Statement of Environmental Effects

S.96(1A) Application to vary SSD 6078

**Oakdale Central, Horsley Park (Lot 21 in
Deposited Plan 1173181) (UNIT 2B)**

June 2015

Figure 1 - Approved site plan

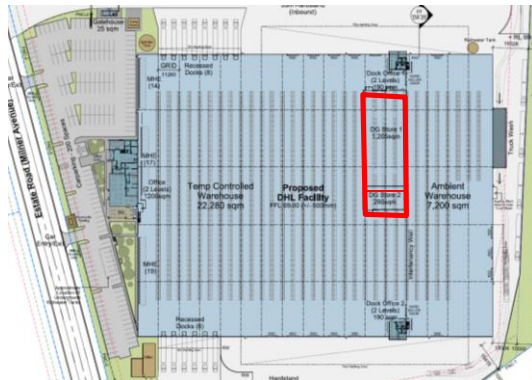
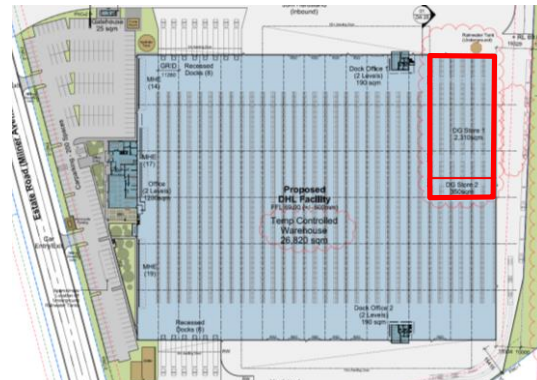
- + Relocated from centre of the warehouse to the south eastern corner

Figure 3 - Proposed DG store layout

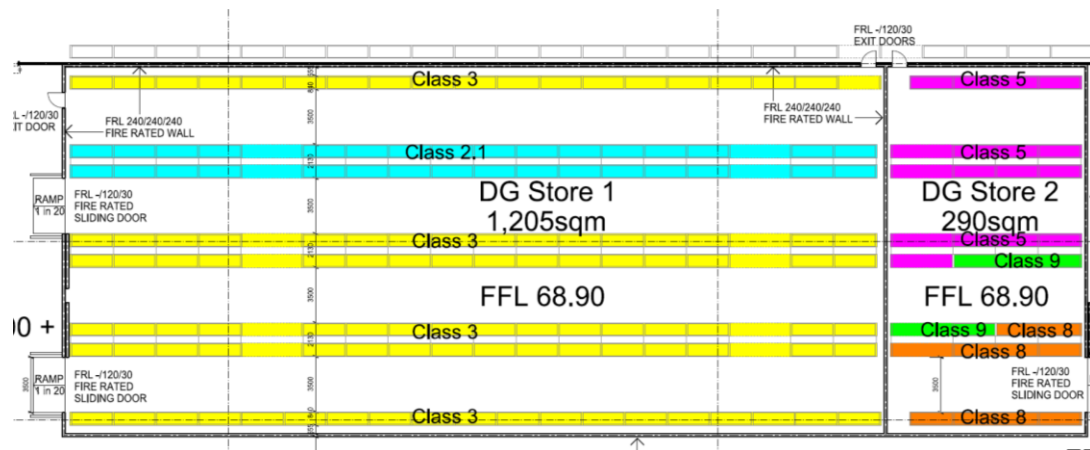
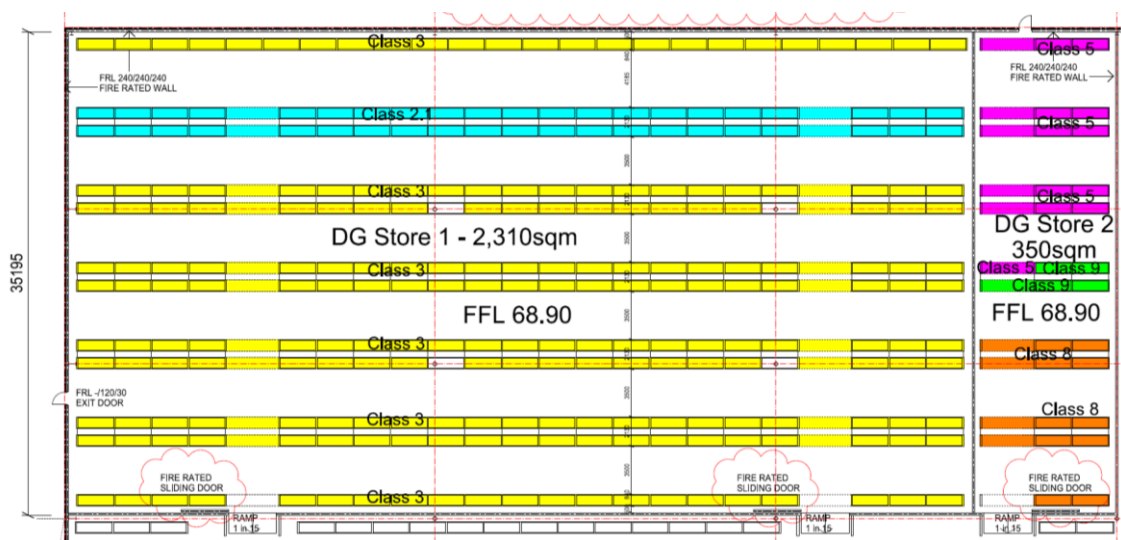
- + Increase in size from 1,495sqm to 2,660sqm:
